RESPONSE TO 2.12.14 STAFF COMMENTS

CLASS II MODIFICATION 2019 8.2.2019

BLDG III ELEVATIONS

A3.4

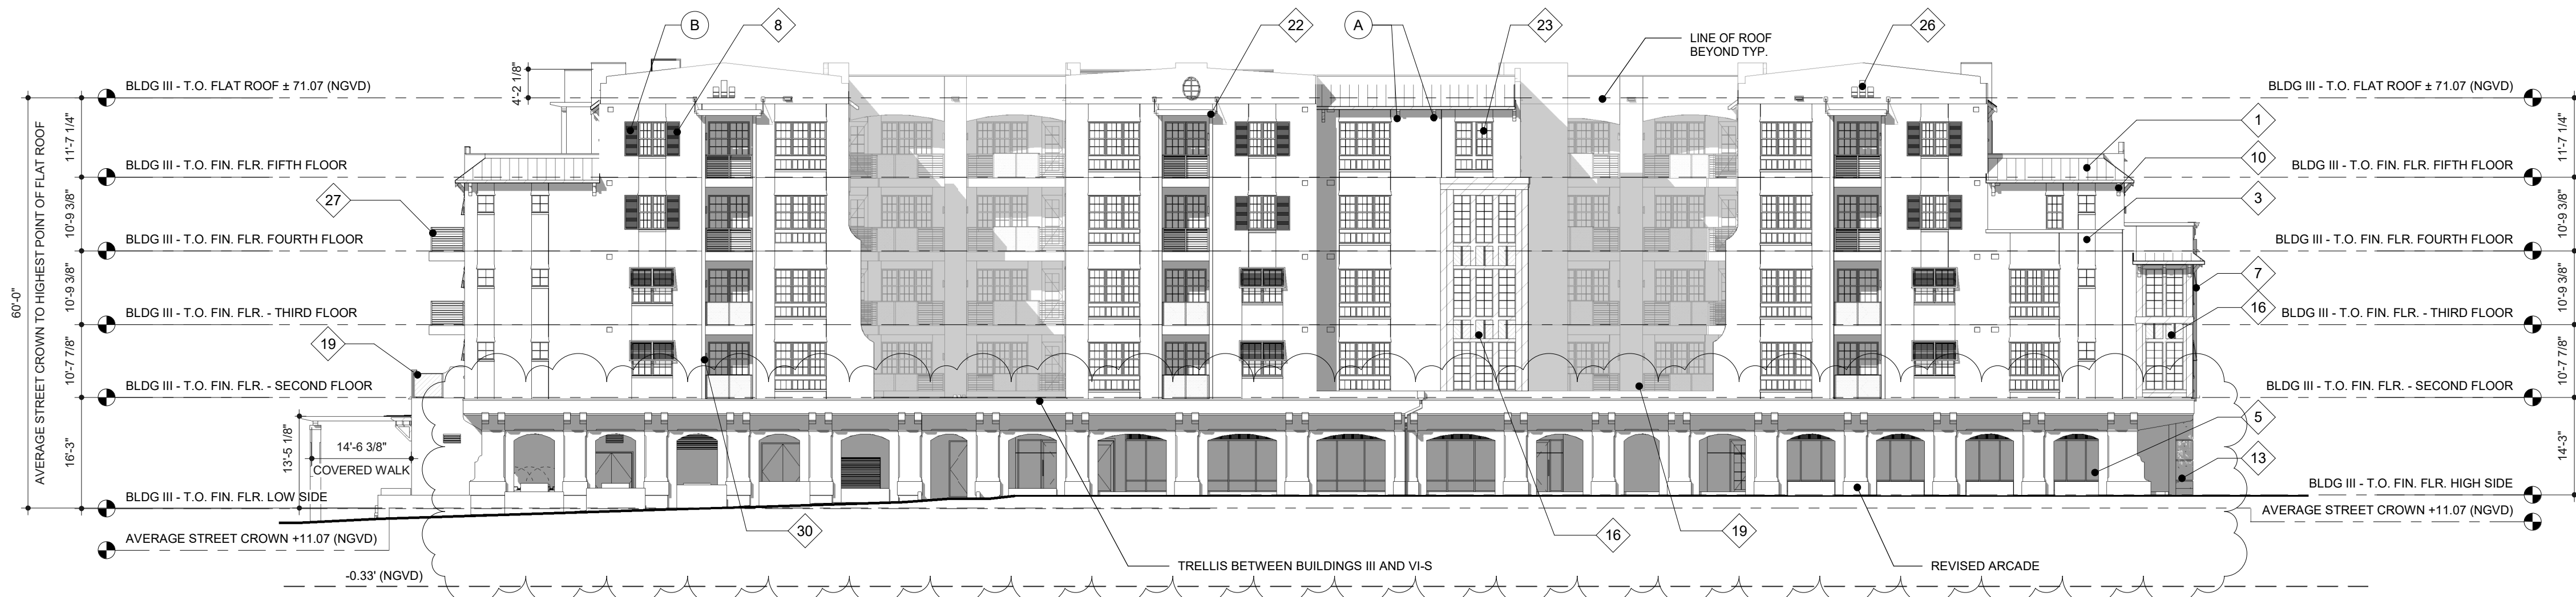
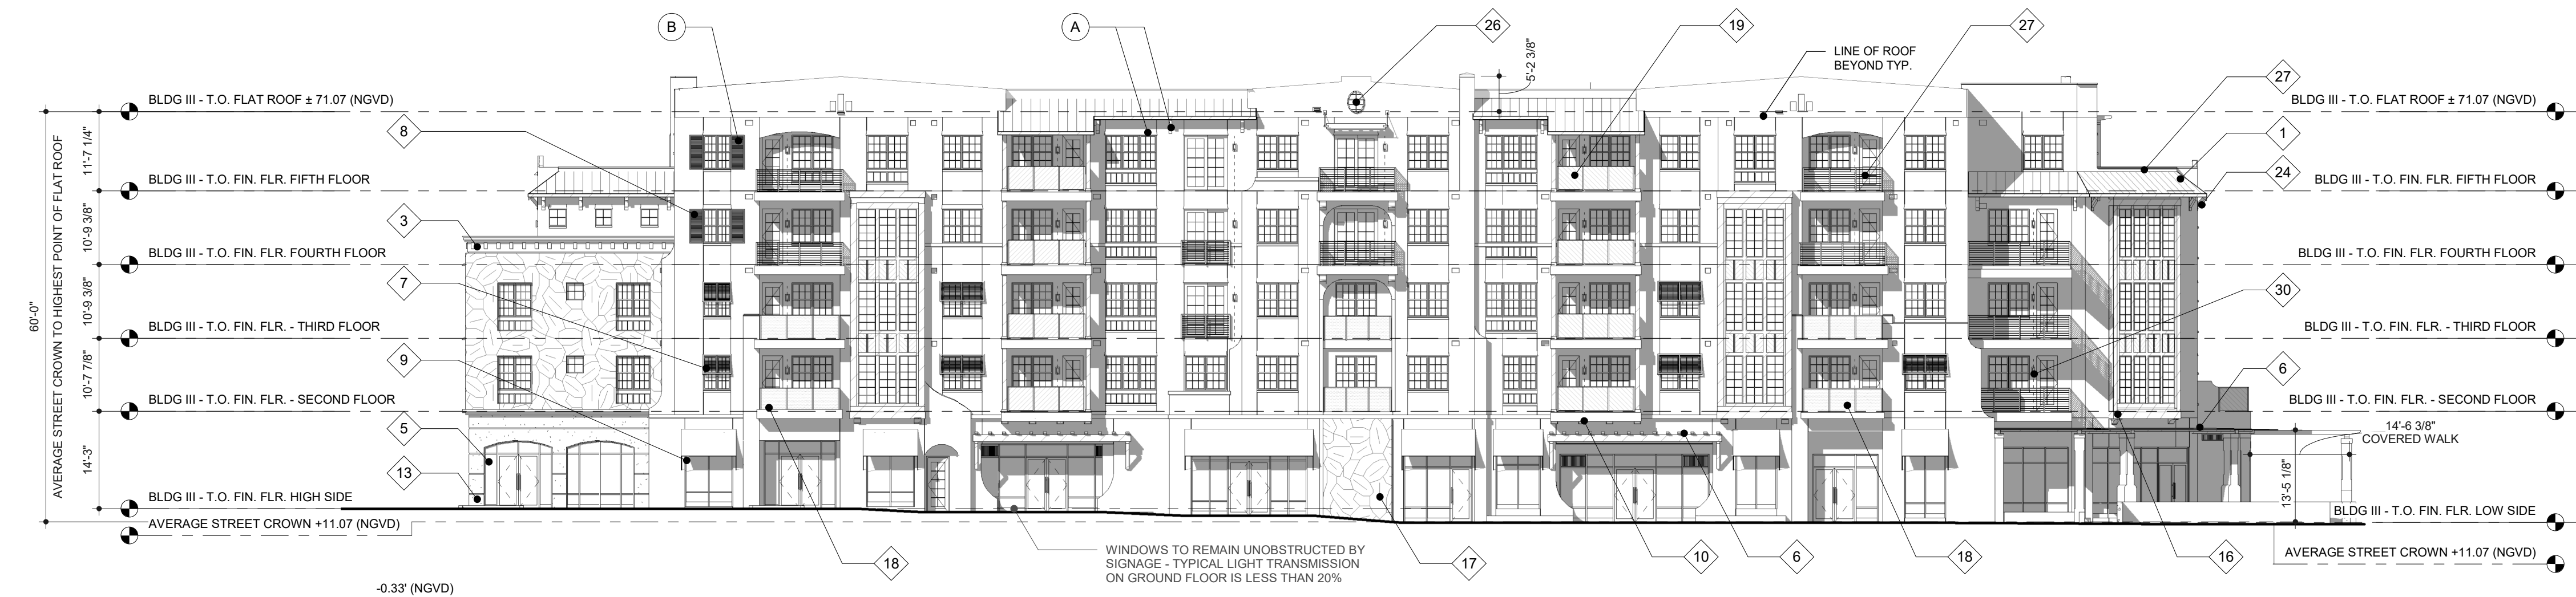
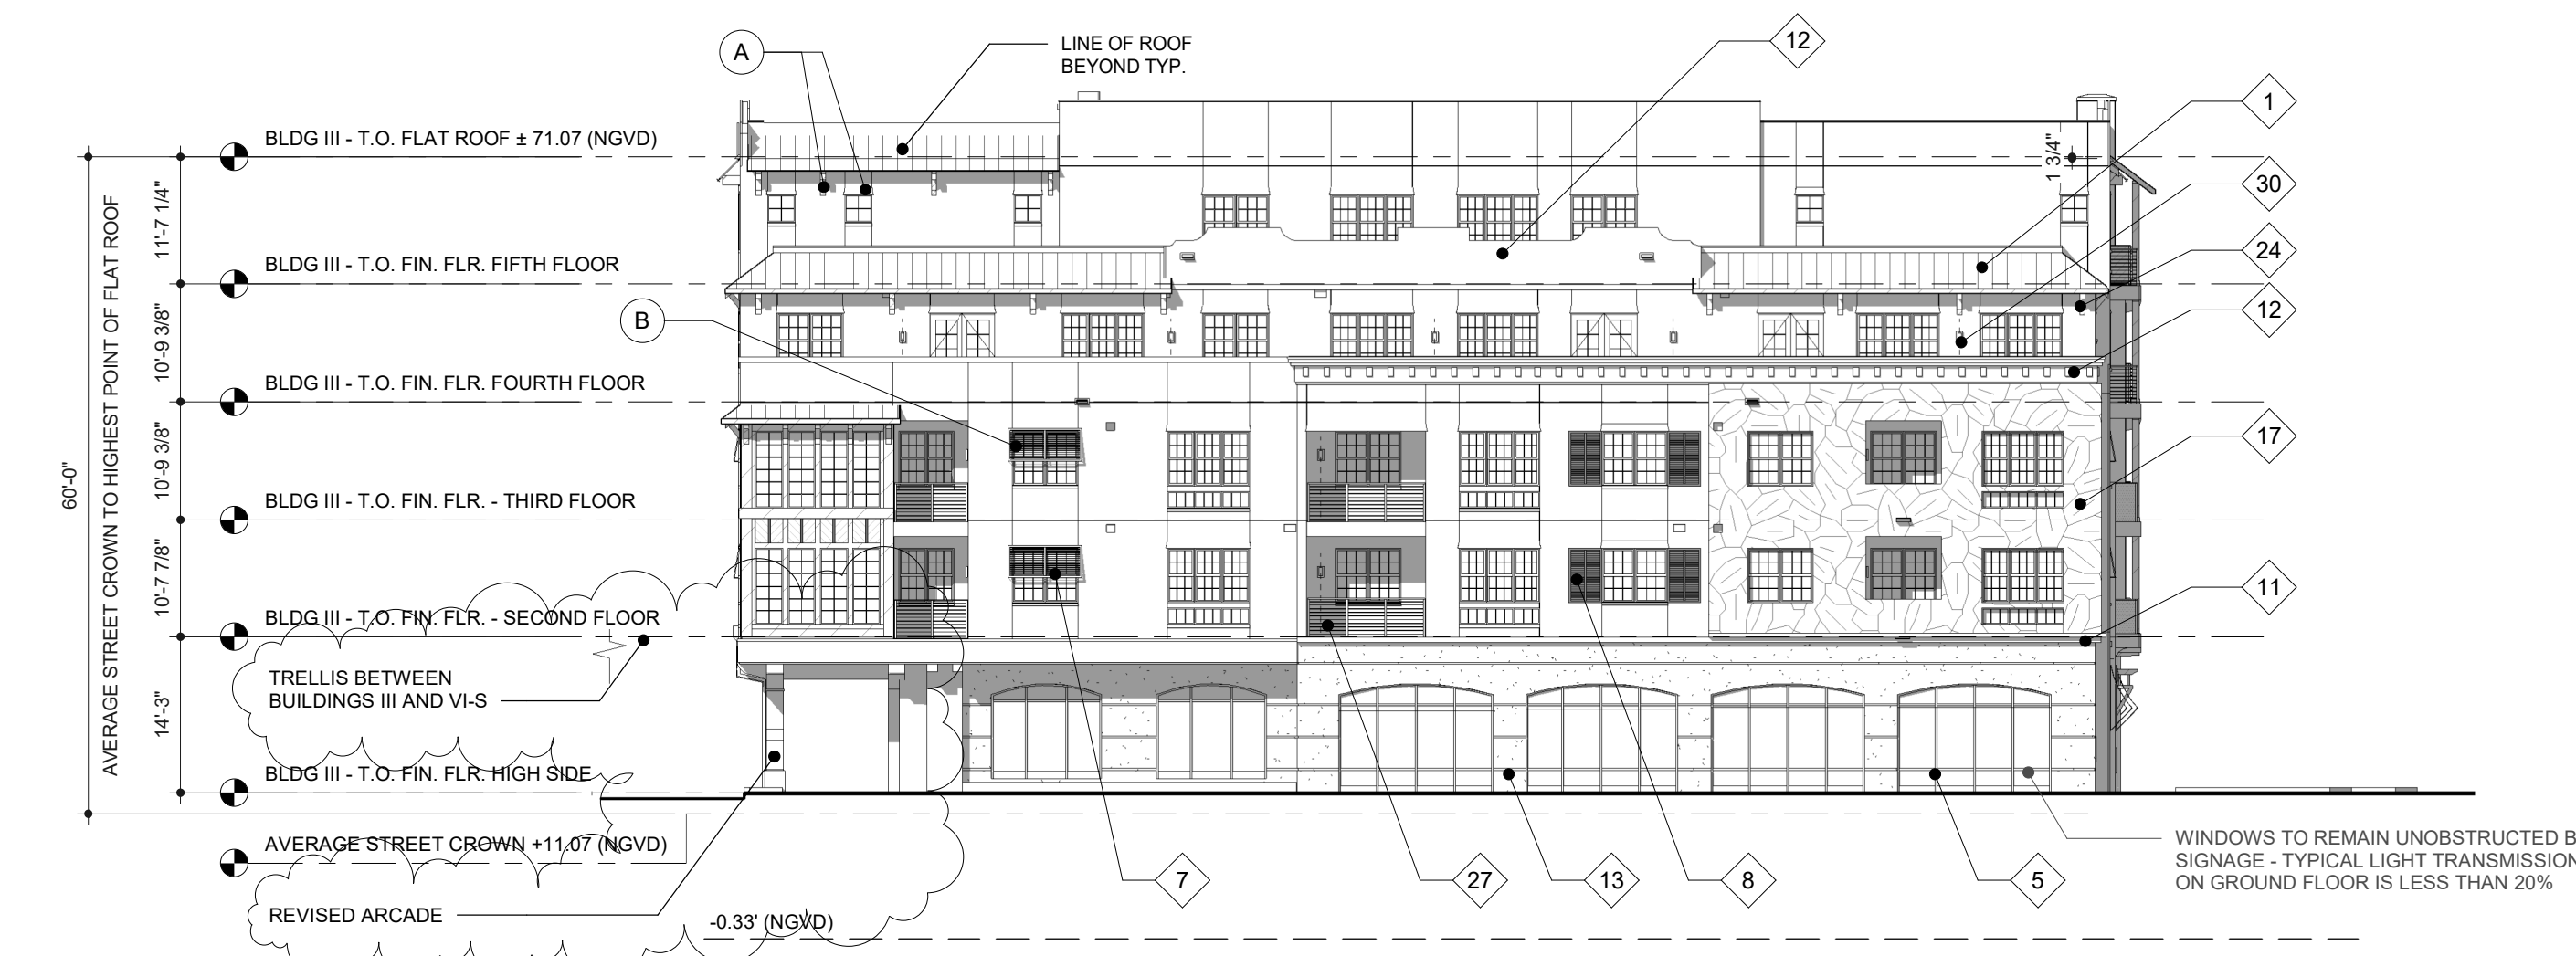
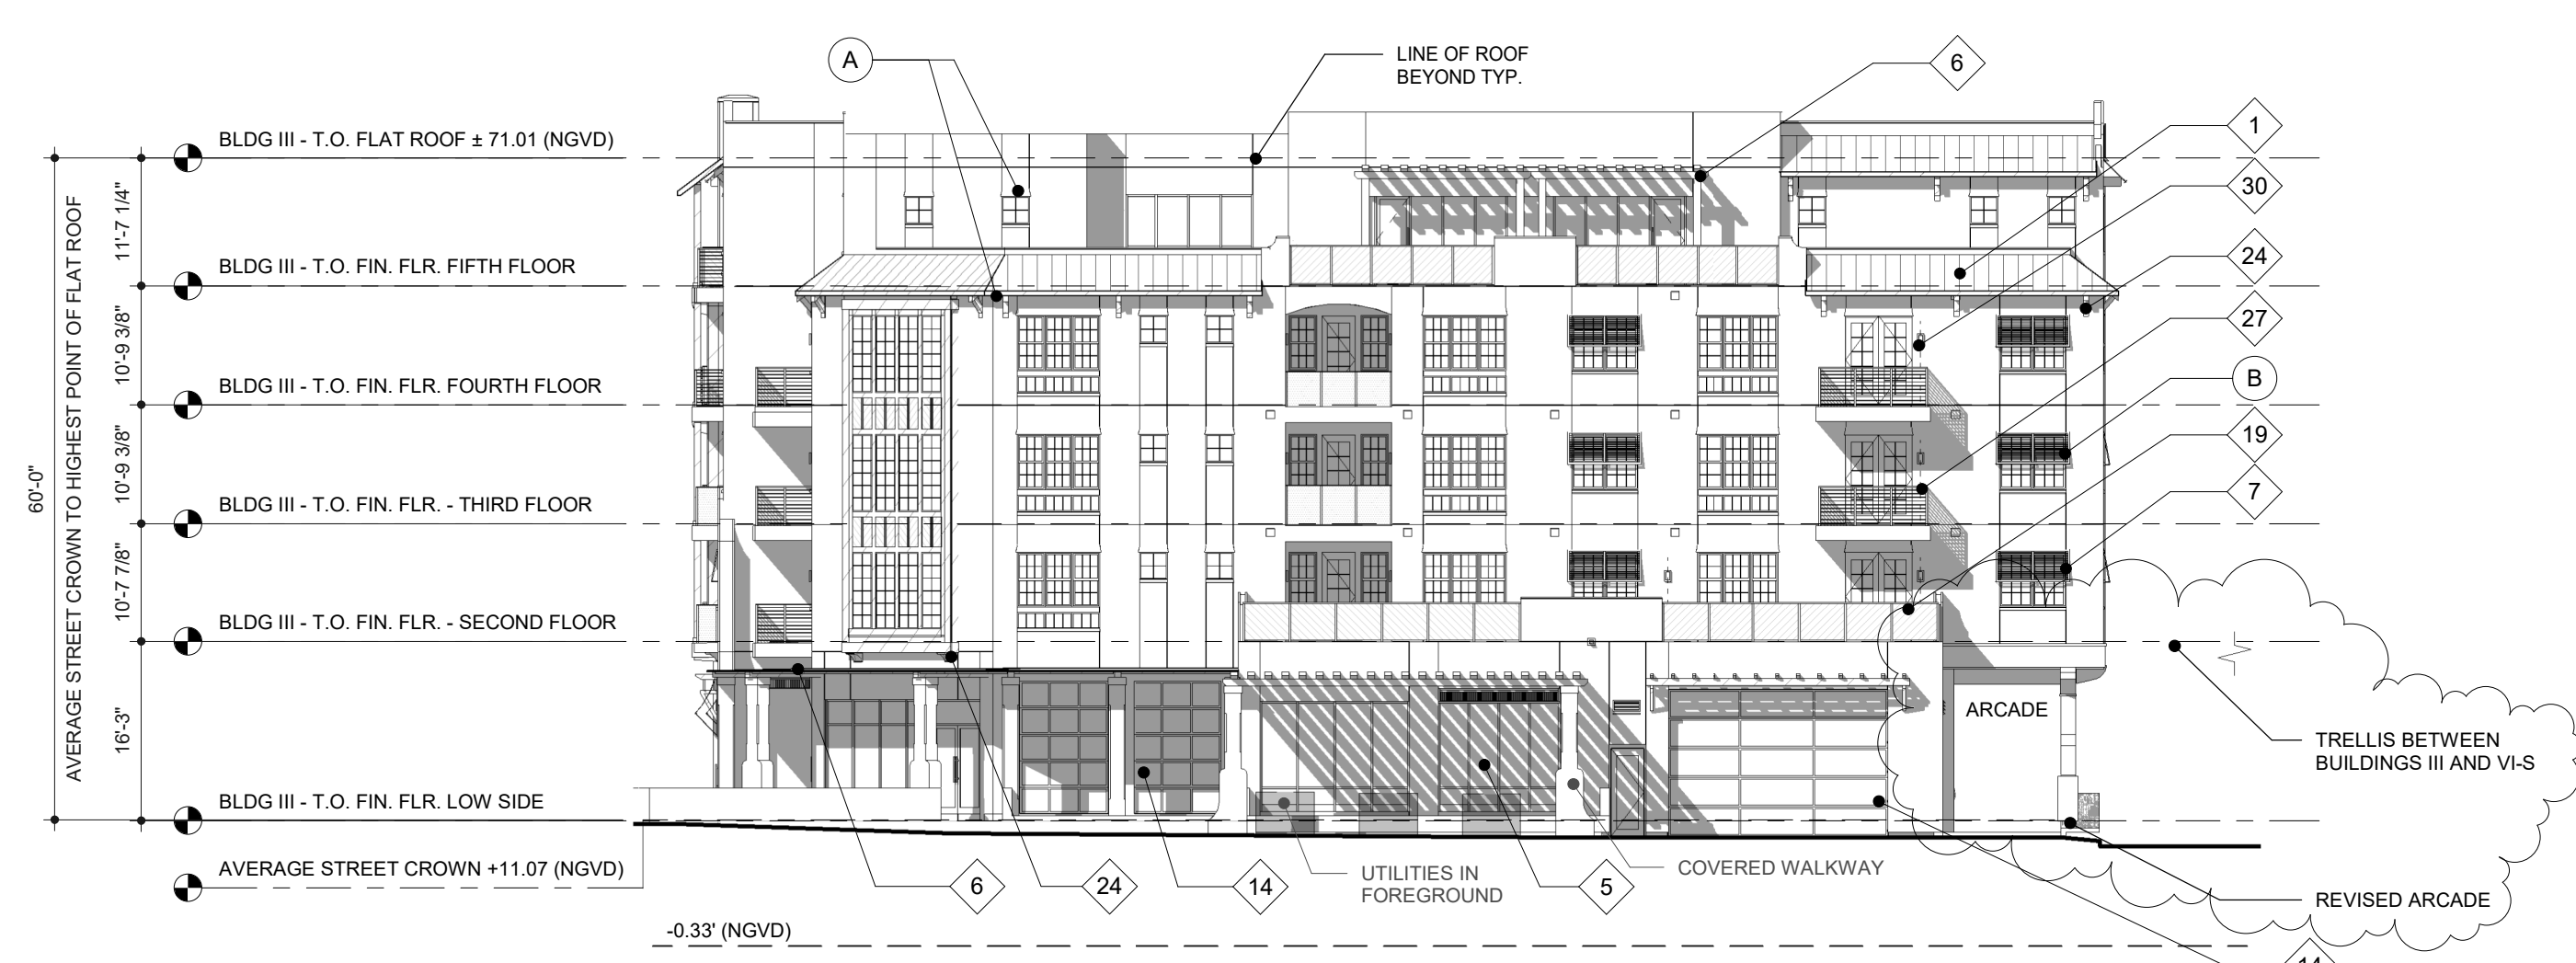
- BUILDING III NORTHWEST FOOTPRINT ADJUSTED DUE TO ADDITION OF RAMP AT NE 6TH AVENUE
- WINDOWS OF THE BUSINESSES AND OFFICES REMAIN UNOBSTRUCTED BY SIGNAGE
- LIGHT TRANSMISSION FOR GROUND FLOOR GLASS AREA TO BE NO GREATER THAN 20%
- KNOX BOXES TO BE PROVIDED AT ROLL DOWN GATES
- GREEN WALL IS CONSIDERED A TRELLIS WHICH SHALL BE ALLOWED TO ENCRATCH INTO SETBACK ALONG FEDERAL HIGHWAY
- ADDED INGRESS/EGRESS RAMP AT NE 6TH AVE

- ADD ARCADE ALONG THE NORTH ELEVATION
- ADJUST POSITION OF LOADING AREA
- ADJUST EAST AND WEST ELEVATIONS DUE TO ADDITION OF ARCADE.

GENERALLY REVISE ELEVATIONS TO BE MORE CONSISTENT WITH ANGLO CARIBBEAN, INCLUDING:

- SCULPTED FORMS AT ARCADE AND AT FEATURE ELEMENTS OF THE BUILDING
- RE-SCALE WINDOWS AT CORNERS
- WOOD DETAILING AS ACCENT AT VERTICAL FORMS
- ENWANCE DETAIL AT BUILDING CAP
- RE-DETAIL ARCADE AND LOW RAMP FORMS

- REVISE DETAIL AT ARCADE
- ADD TRELLIS BETWEEN III & VI-S
